Re : Proposed Landfill at Allawuna Farm Lots 9926, 4869, 5931 & 26934 Great Southern Highway York

Please accept my submission to oppose the development of a Landfill Class 11 Facility on the above property and also to the Allawuna Farm Landfill Supplementary Report dated February 2015.

Plan showing long sections of Ground water flow

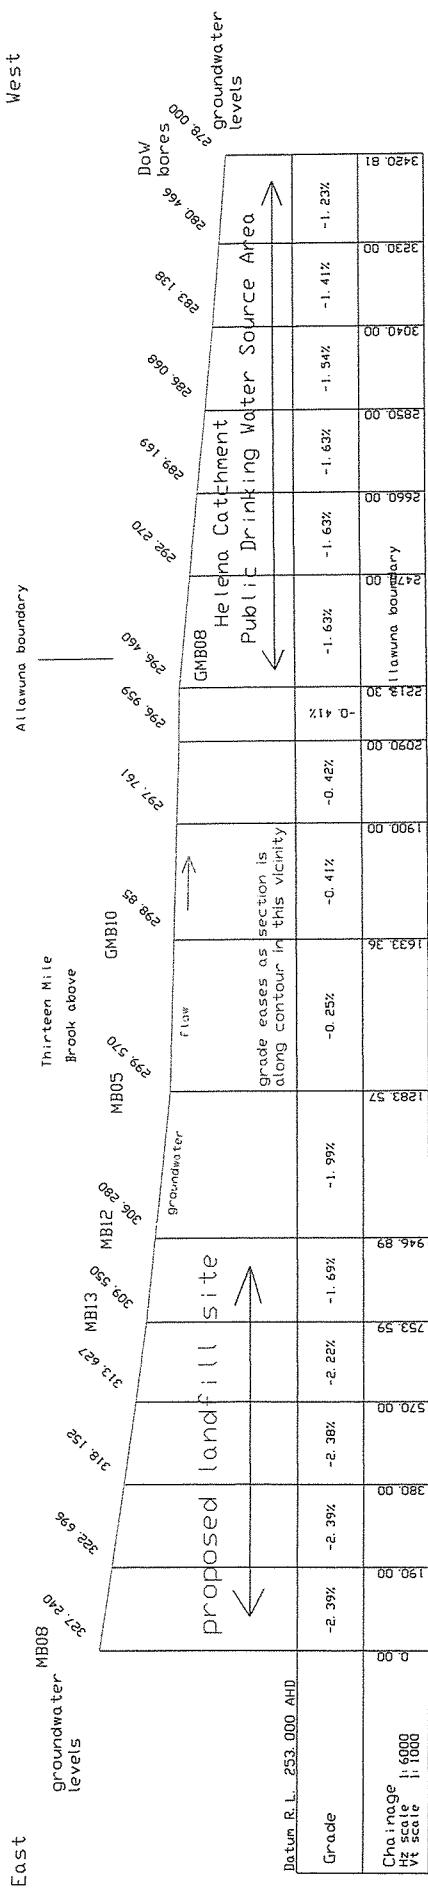
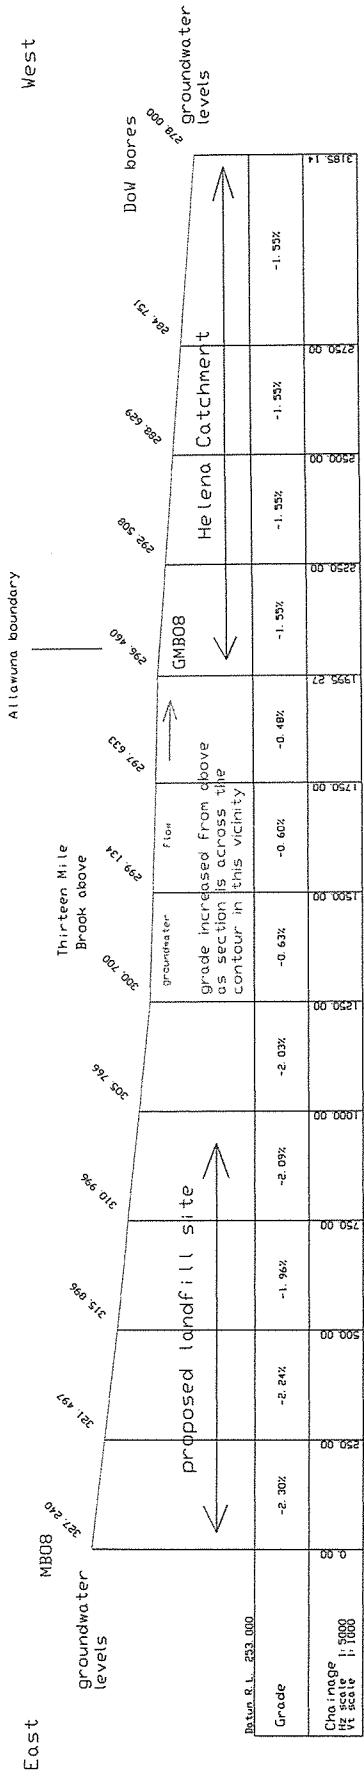
Ground water flow into the Helena catchment

Section of westerly Gw flow from bore MB08 through MB13, MB12, MB05, GMB10, GMB08 to Dow bores

Section of westerly GW flow from MB08 to GMB08 and Dow bores

Figure 2.1 Topography and physiographic divisions

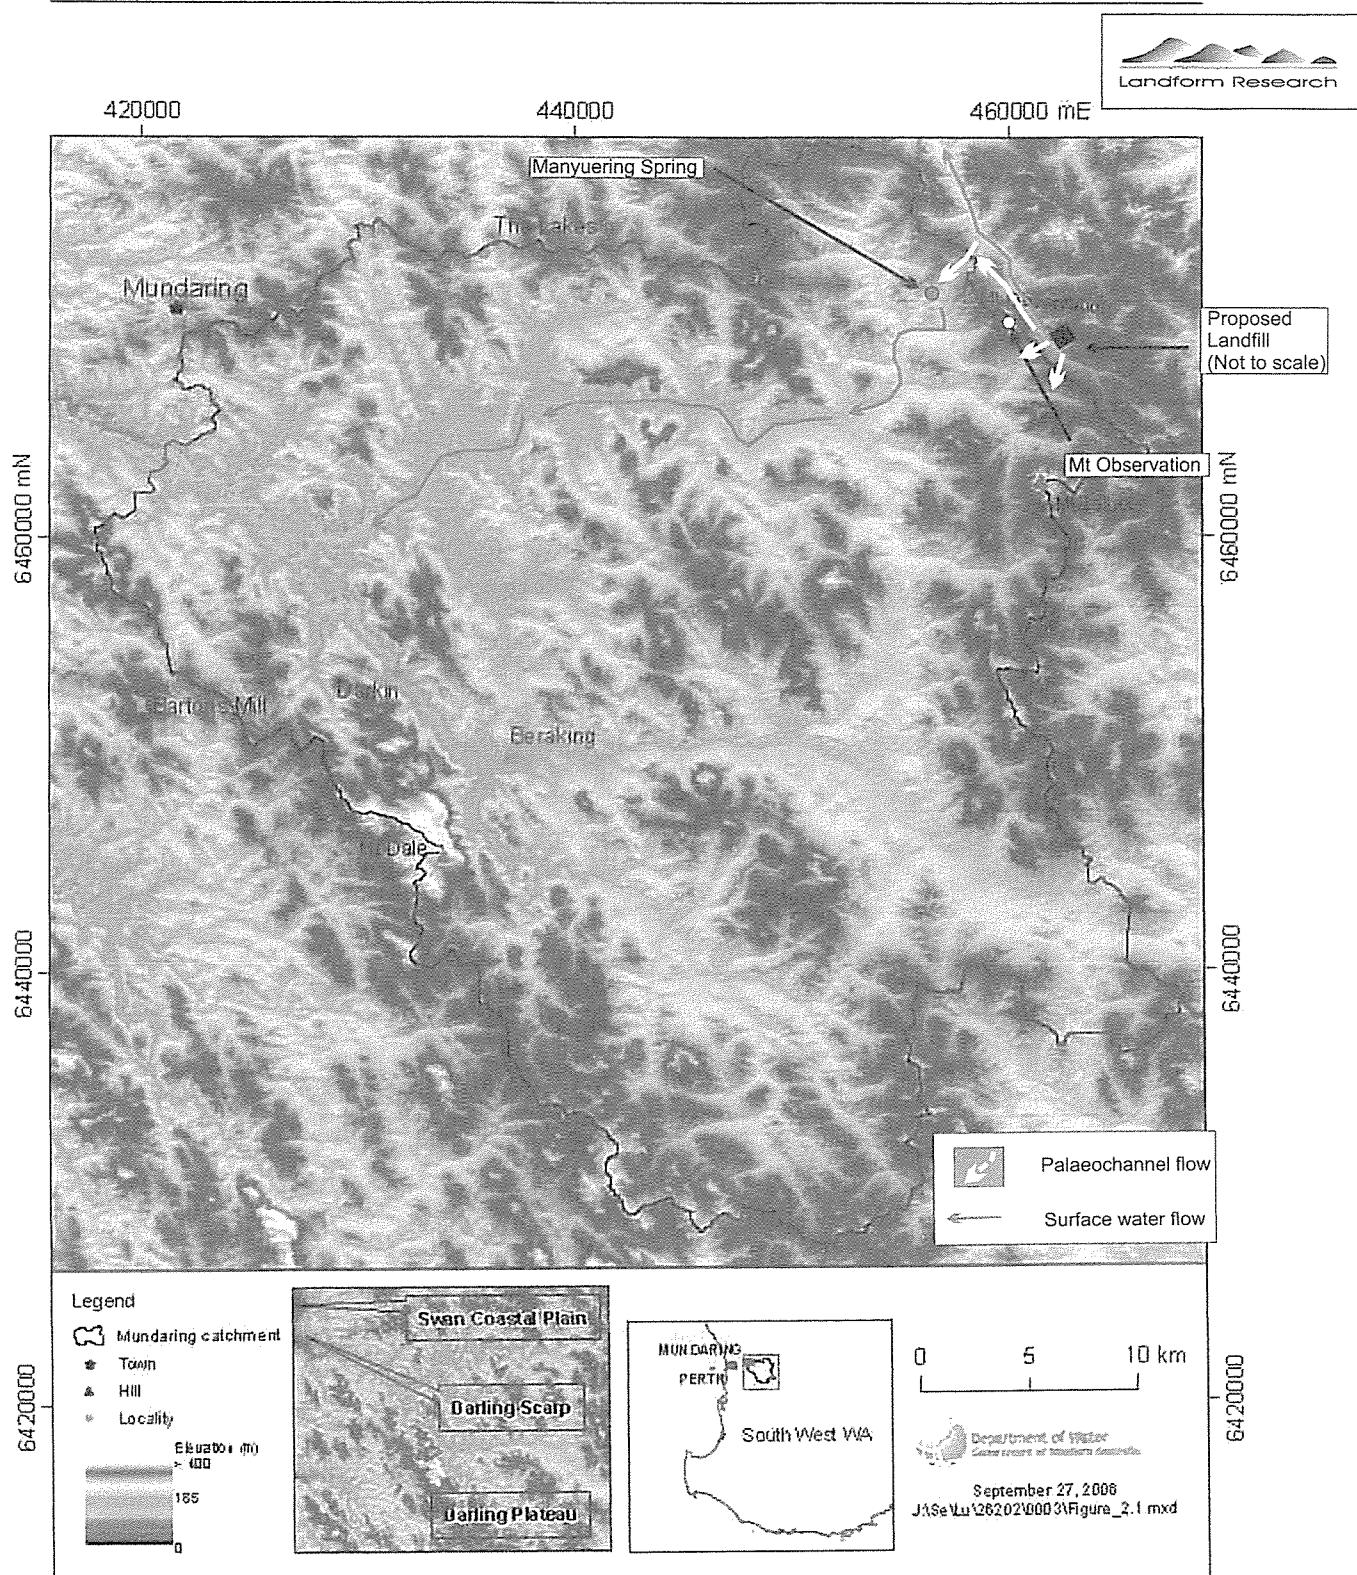
Mapping does not show the palaeochannel flows under the surface water drainage divide

Surface water flows outside the Helena Catchment.

Palaeochannel flow most likely flows into the Helena Catchment

Figure 2.2 Hydrology, subcatchments, gauging stations, rainfall and potential evaporation

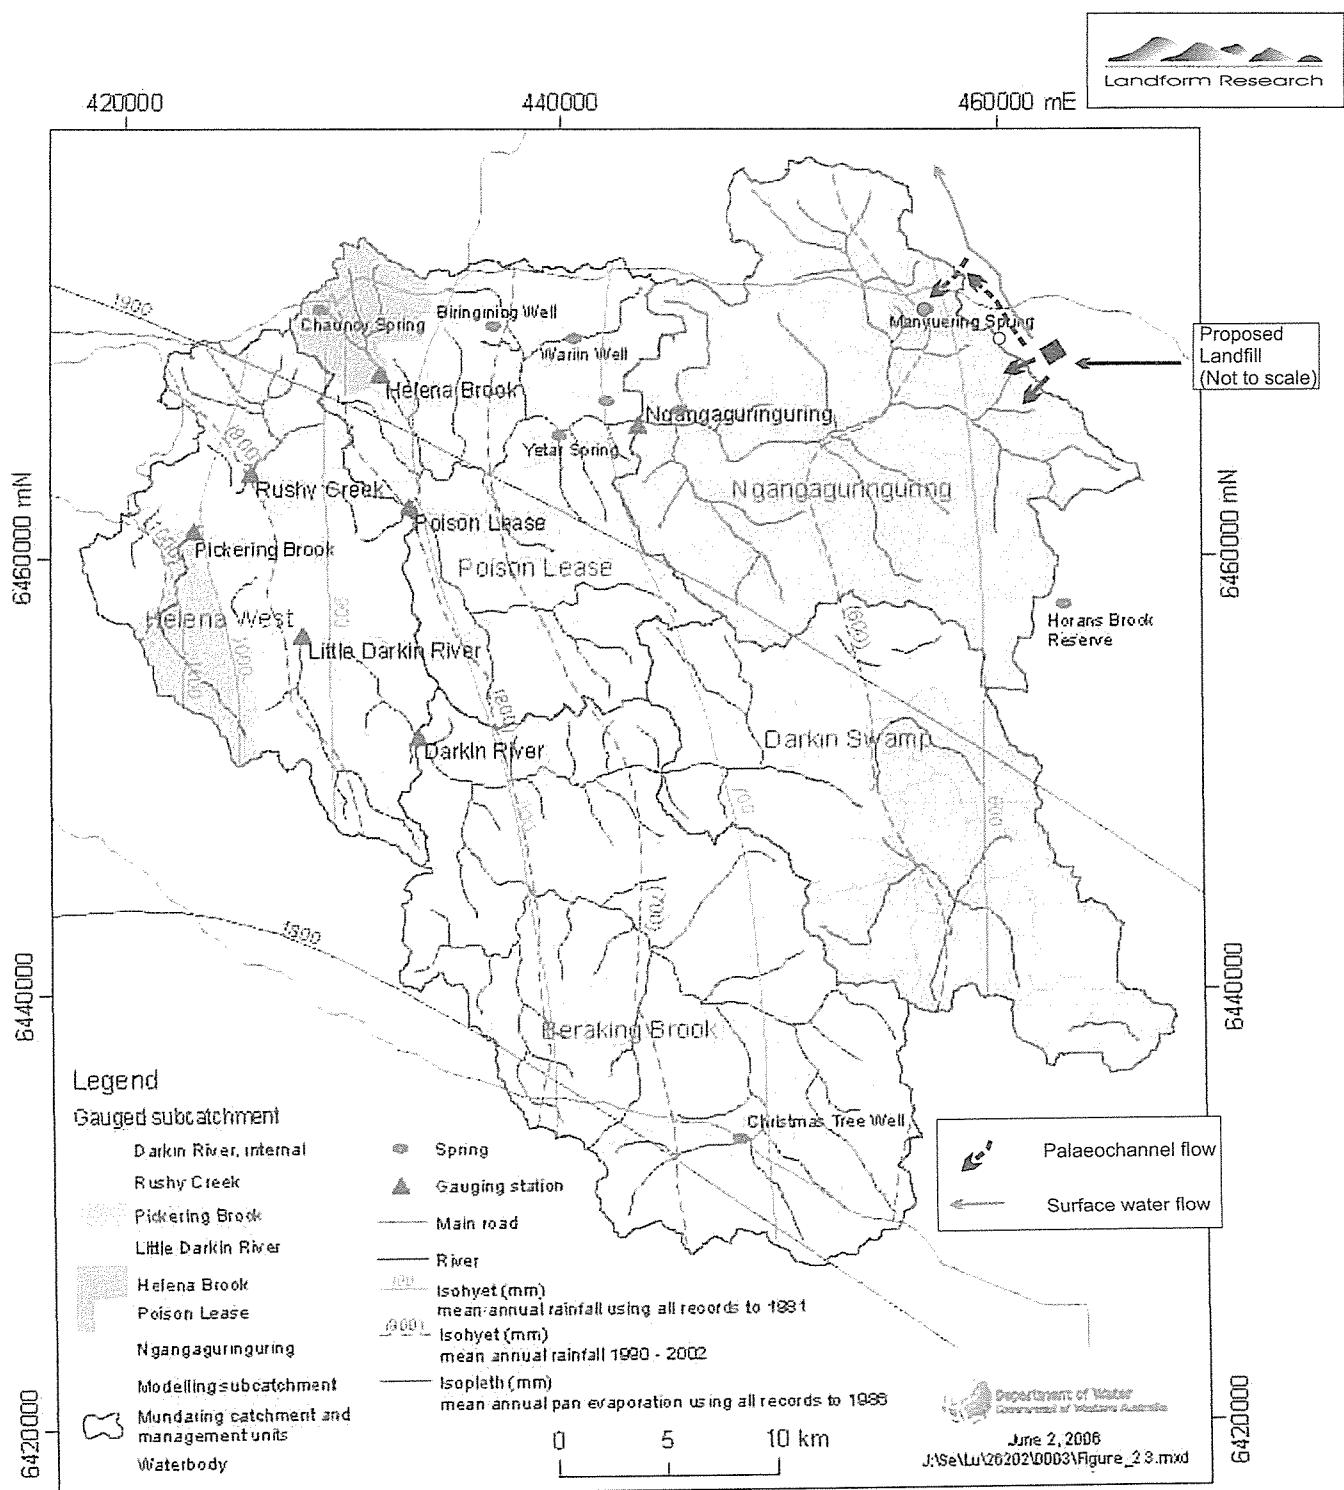
Mapping does not show the palaeochannel flows under the surface water drainage divide

Surface water flows outside the Helena Catchment.

Balaoochannel flow most likely flows into the Helena Catchment

Figure 2.5 Hydrogeology

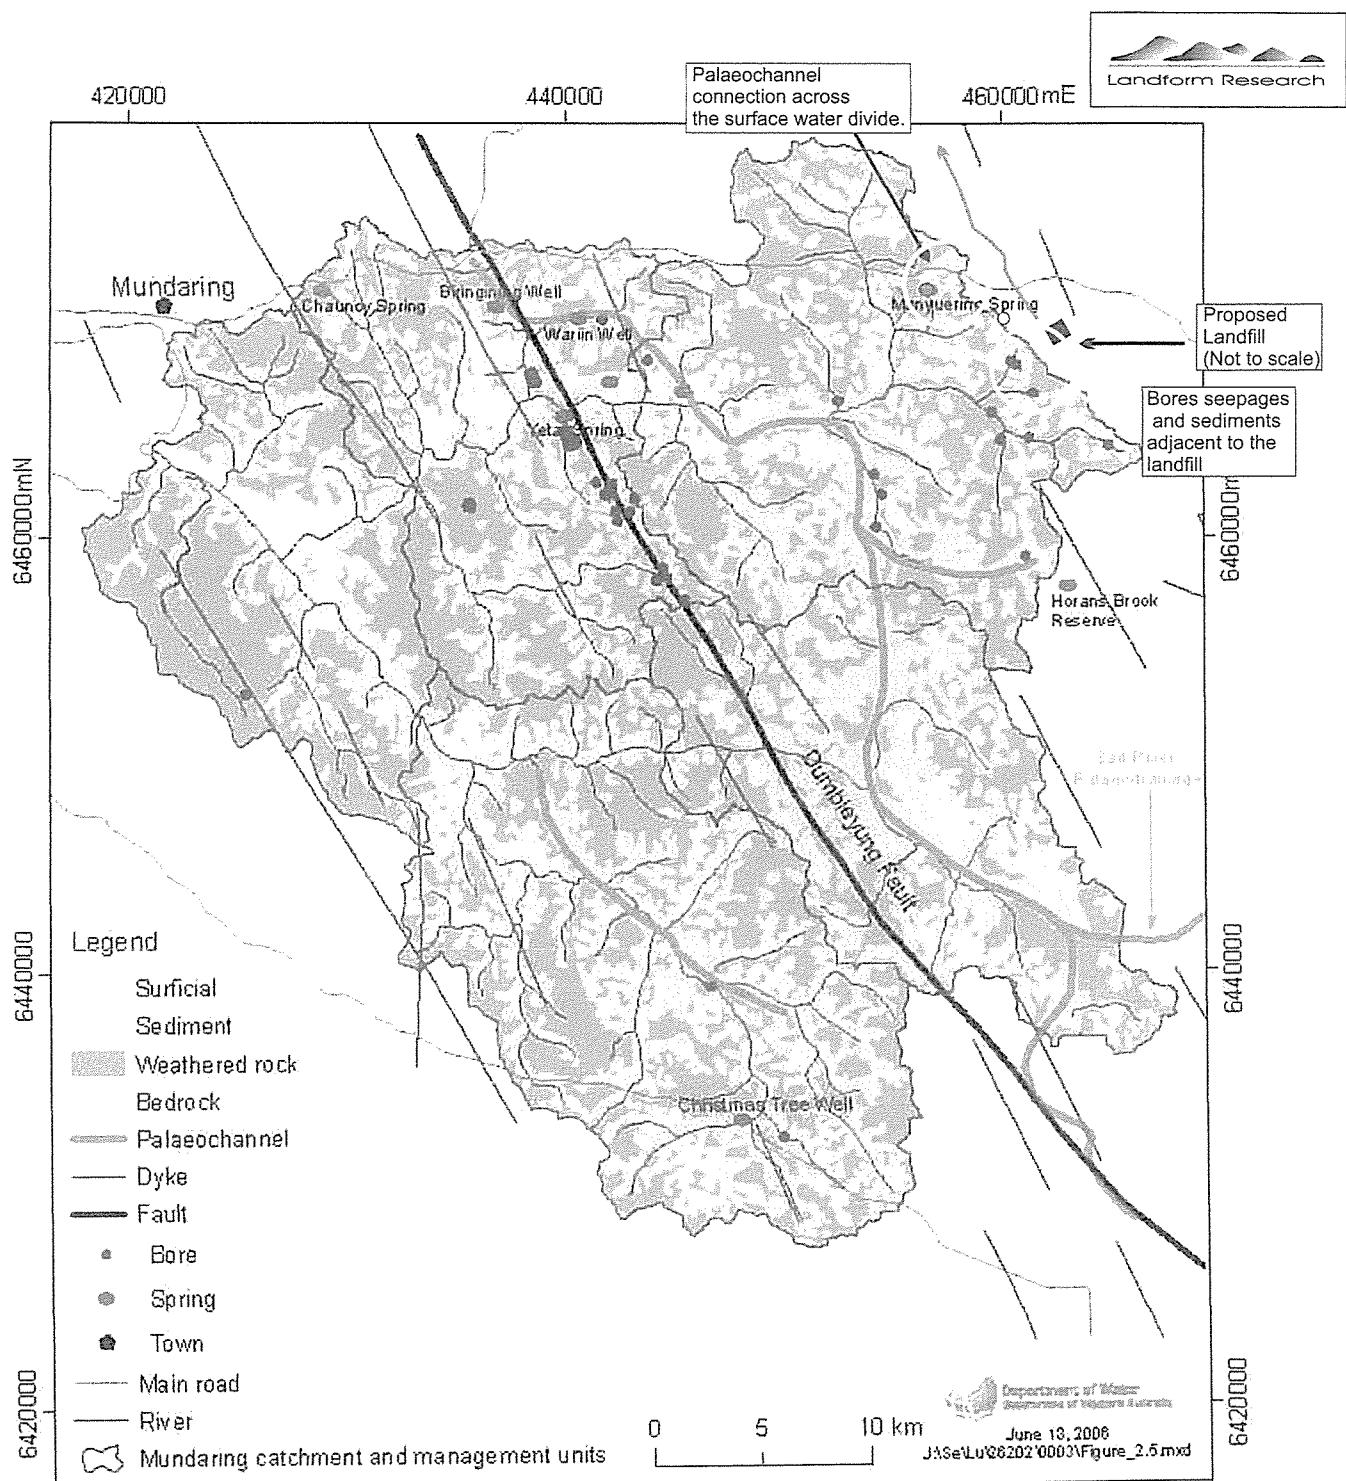
Notice the palaeochannel connection from the valley outside the Helena Catchment to Manyuering Spring, shown in green as sediment. Notice the springs and bores associated with sediments that receive water within the Helena Catchment.

FIGURE 7

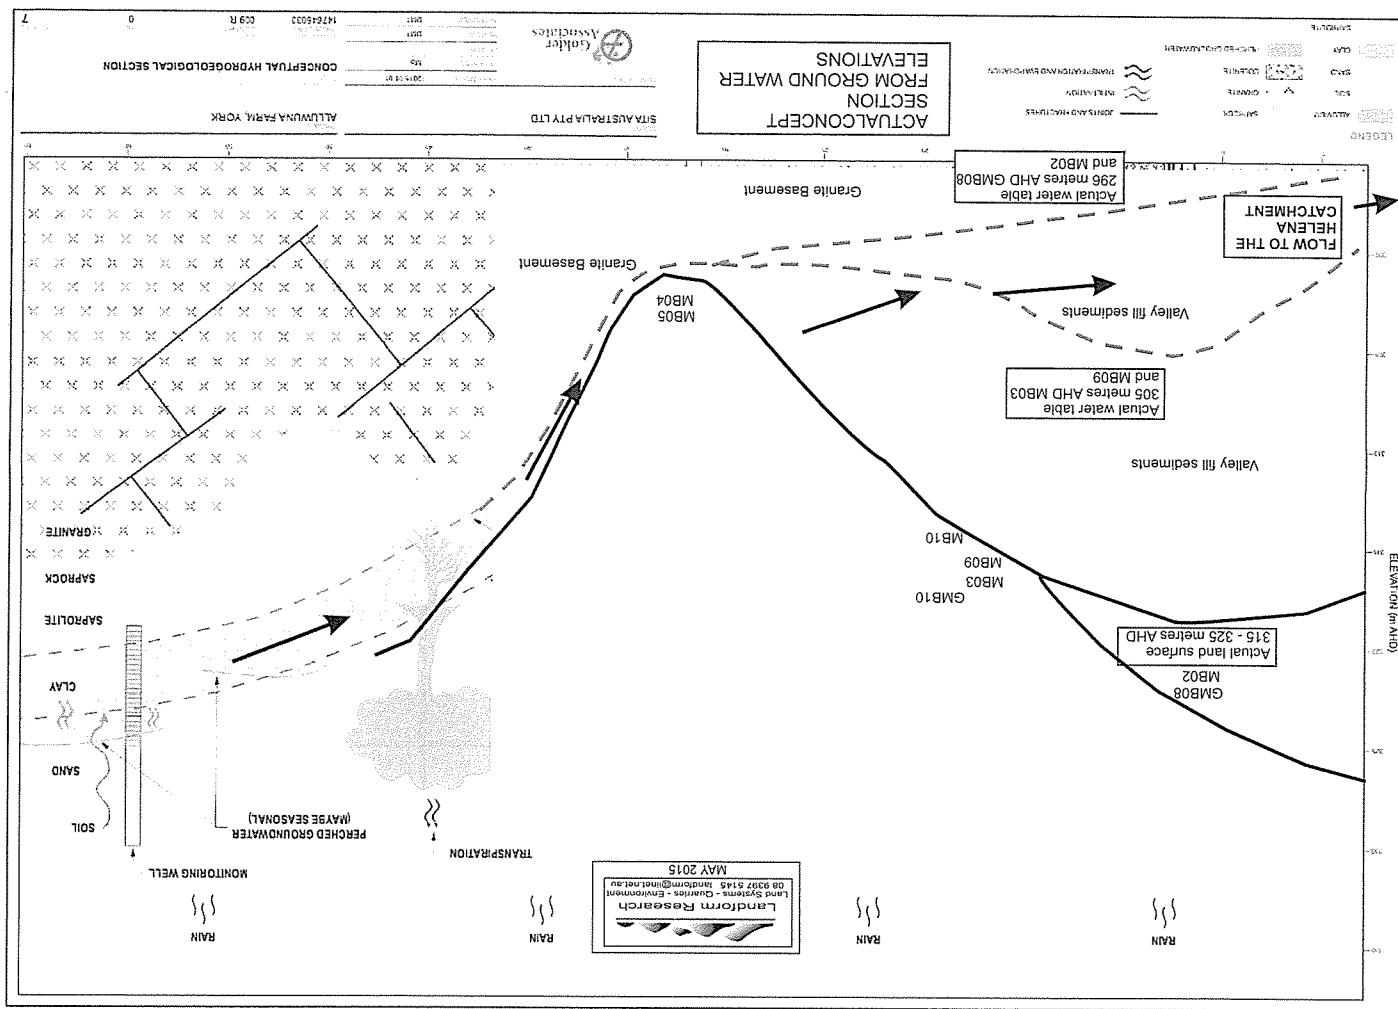
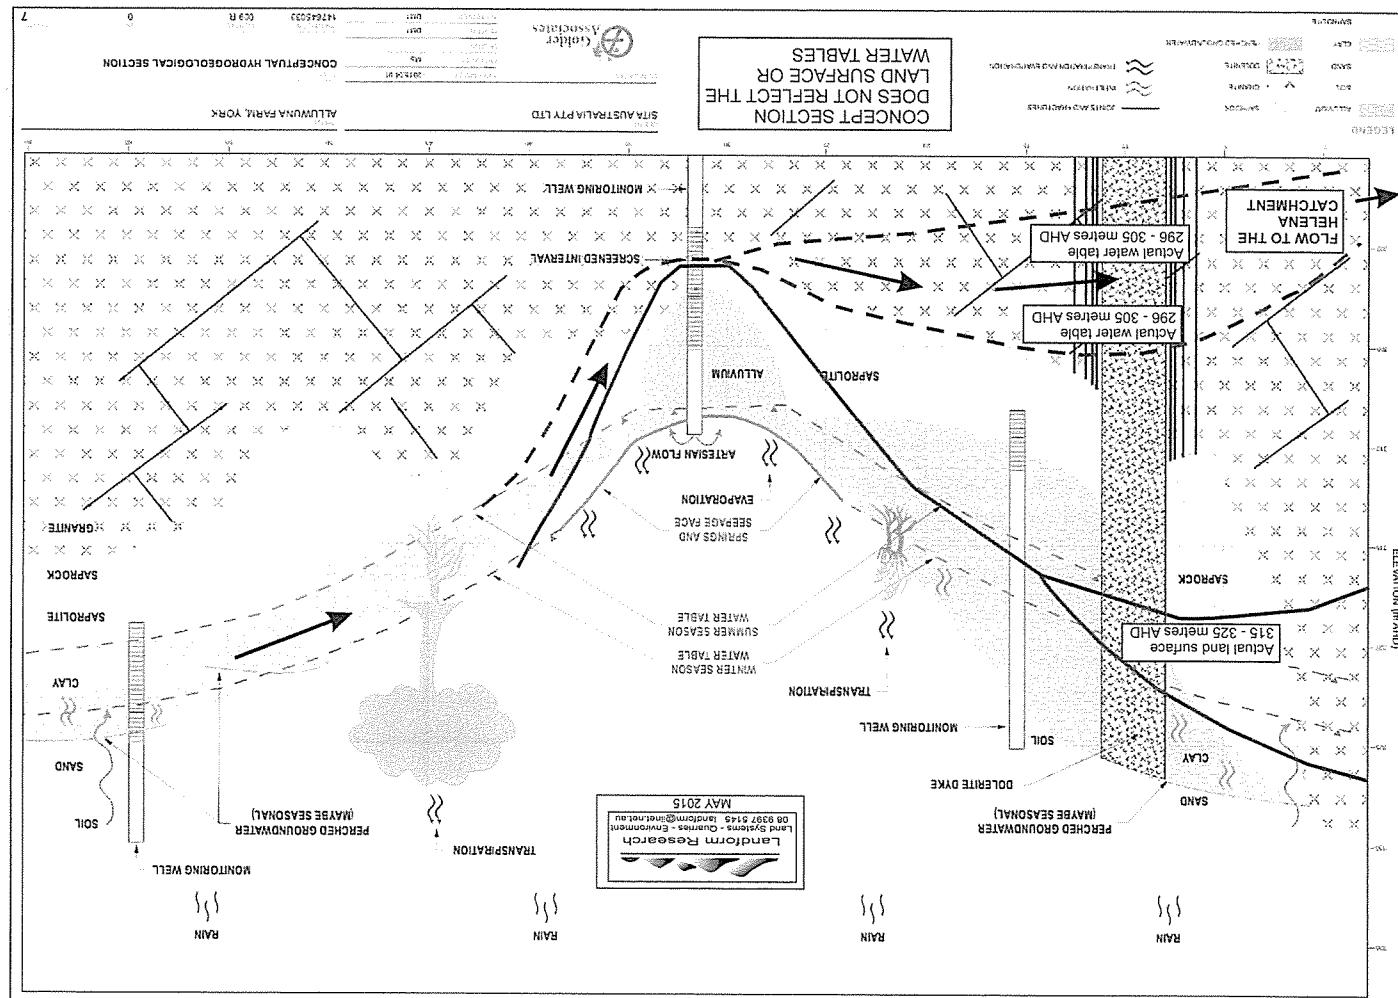
Golder Figure 7 is also incorrect and dated 2015-04-01, presumably drawn on 1 April 2015. That is after all the drill hole and groundwater data for all holes was available (including GMB01 – GMB10). The section does not even reflect the groundwater monitoring shown in Golder’s Figure 8. I have overlaid the groundwater elevations and flow net on the published contours as Figure 7.

I have included Golder Figure 7 as my Figure 7 and a corrected version of Golder Figure 7 also in Figure 7. I have also provided a hydrogeological section based on the land surface and groundwater elevations as Figure 6.
